1 Introduction

Shifting now to the primary focus of these Comments, this part will examine the potential impacts of the proposed Project on the recreational windsurfing Resource at CPSRA.

The current DEIR claims "no significant impact" would take place on the Resource despite a wall of buildings some 200' above sea level possibly being constructed just 500' immediately upwind along the extent of the shore where windsurfing takes place.

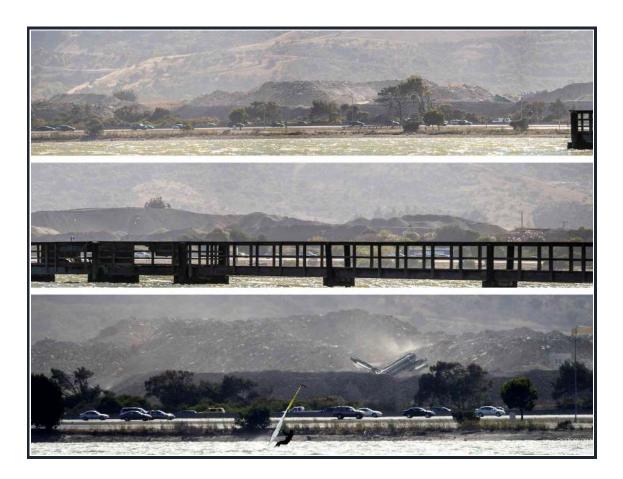
Given their dedication to this unique and valuable Resource, the frustration and disappointment among those of the interested public who reviewed the proposed Project and Analysis was staggering. It is unfathomable to imagine that a possible virtual wall of 4,200' of construction up to 200' above sea-level in some areas along the Western edge of the Practical Sailing Area would have "no significant impact" on wind-flow on a site that begins just 500' downwind.

Figure 4: Existing Dirt Walls from Soil Processing on Baylands Dirt mounds that rise some 50' to 70' above surrounding grades already border portions of the Western area of CPSRA [11]. The proposed Project could expand intense development North and South for a total length of perhaps 4,200' and increase the effective height of obstructions along this Western shore up to 200' above sea level in some portions. This figure is provided for scaling reference.
